MEMORANDUM

TO: District of Columbia Zoning Commission

FROM: *JS* Jennifer Steingasser, Deputy Director
Development Review and Historic Preservation

SUBJECT: ZC #15-04 - Final Report - Consolidated PUD and Related Map Amendment by Comstock LLC, (Square 3788 Lot 814)

6th Street Frontage - Potential context with existing semi-detached homes

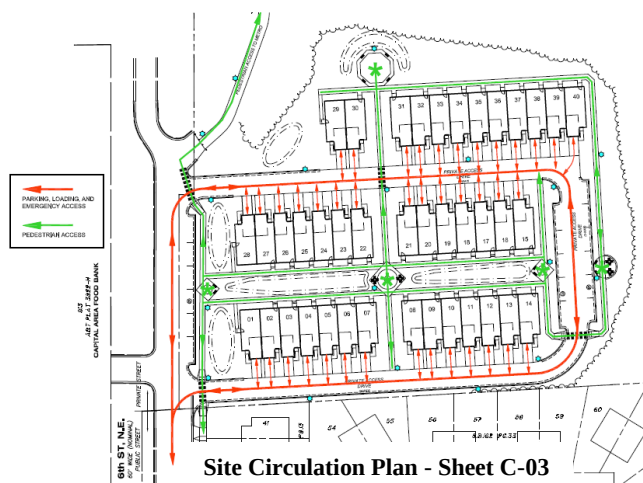
The proposed architecture while similar to the Emerson Park residential PUD to the north, would be an improvement in material use on this PUD site. The Commission requested additional drawings/renderings of the individual units and how the dwellings would fit into the neighborhood context (Exhibit 16, Item 1, Page 3,). The applicant explained the architectural design elements that would be included for interest and variable articulation, as viewed from the mews.

The applicant also addressed the Commission's concerns regarding the interior layout of the units with respect to the opening of the 2nd floor bathroom, which was reconfigured in the revisions (Exhibit 16, Item 1, page 4), (*Compare Exhibit 6A1 Sheet A8 with Exhibit 16A Sheet A10*). Respectfully, the original opening would be preferable, since the door would not be located and opened within the kitchen area's view.

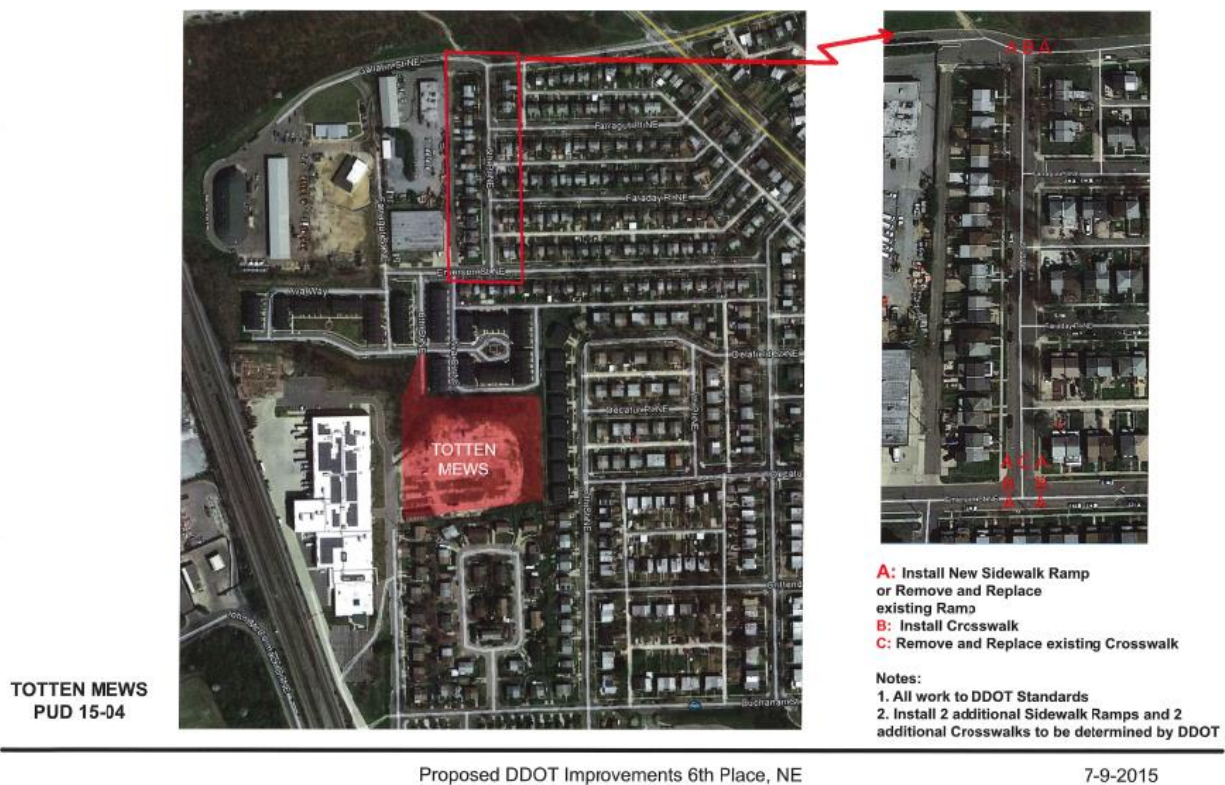
The Commission requested a transportation analysis describing how pedestrians, bicycles and visitors would access the PUD site, including how the visitors would pull up and enter the dwellings (Exhibit 16, Item 1, page 5). In response, the applicant has initiated a traffic analysis of the transportation aspects of the development. The site circulation plan was included in the original submission at setdown (Exhibit 6A2- Sheet C-03) and included here as reference.

The green areas indicate how pedestrians would be able to access the homes' front doors, the PUD site's recreation amenities, as well as Metro. In addition, visitors who may drive, or service vehicles would be able to access 17 on-site parking spaces, which are directly accessible to the 5-foot wide walk path shown as green on the diagram. However, it would seem that pedestrian access to the front door of Unit #29, one of two semi-detached homes to the north would be a trek for a visitor, as the home fronts the wooded area northwest of the site. The

The transportation analysis was received by OP dated July 10, 2015 (Exhibit #25). OP discussed the analysis with DDOT and DDOT concurred that there would be little to no impact, and supported the installation of the bicycle/pedestrian path, built to DDOT's standards. Pedestrian/bike access would enhance the activity within the surrounding area and provide additional residents in support of the new retail offerings around the Fort Totten neighborhood. Currently, Walkscore.com rates this neighborhood location with a walkscore of 33 out of 100; so most errands would require a car. However, it is a 20-minute walk to Metro's 3 lines (red Yellow and Green) and its transit score is rated as excellent at 50%, which means that transit is convenient for most trips, and car sharing is available at that location. The applicant is continuing discussions with the ANC regarding the provision of a car share space on 6th Street NE, and membership fees for homeowners for one year.

Location of IZ units (07/09/2015)

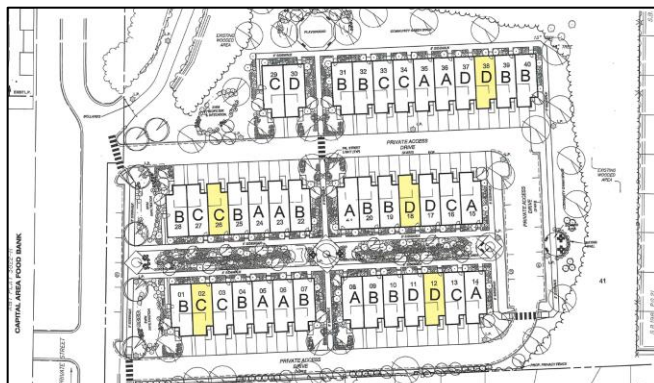
The difference between the required and proposed is 15 square feet, which is negligible in this instance. Therefore, OP would consider the requirement satisfied. An affordable non-IZ unit at 2,205 square feet at 80% AMI is included as a proffer.

This set aside provision has been satisfied in the submission, as indicated in Table 2 prior.
